## New switch for Hybrid Foamatic controller

Due to a modification from our supplier, we have changed the switch for the Hybrid Foamatic controller into a smaller version with straight (instead of bent) cable sockets.

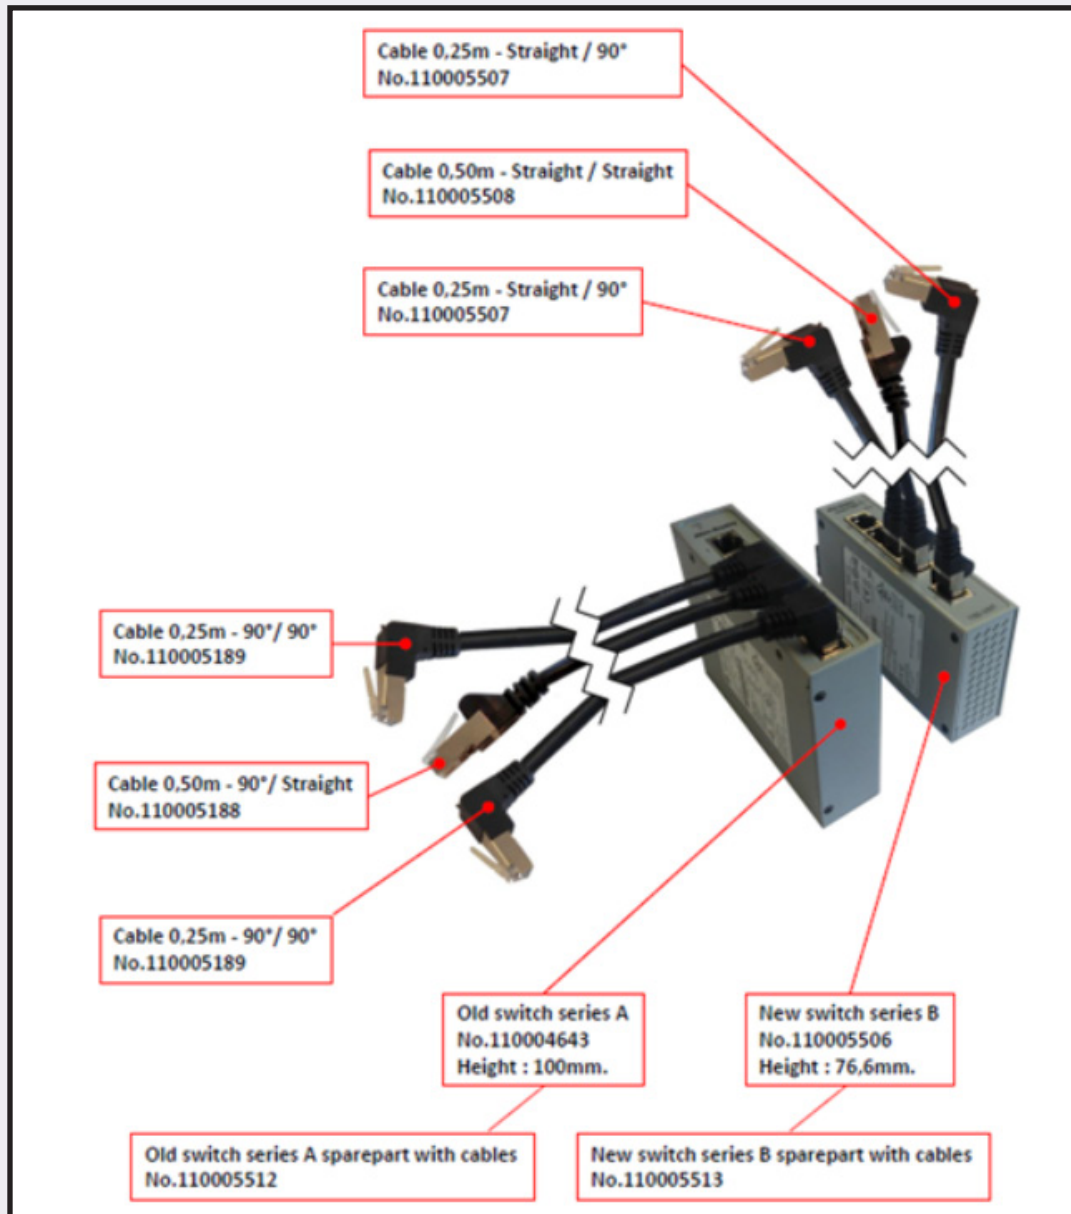
This means for Hybrid Foamatics produced up till 1st June 2017, the switch will be the original with bent cable sockets – item No. 110005512. (switch without cables – item No. 110004643)

For Hybrid Foamatics produced as from 2nd June 2017, the switch will be with straight cable sockets – item No. 110005513. (switch without cables – item No. 110005506)
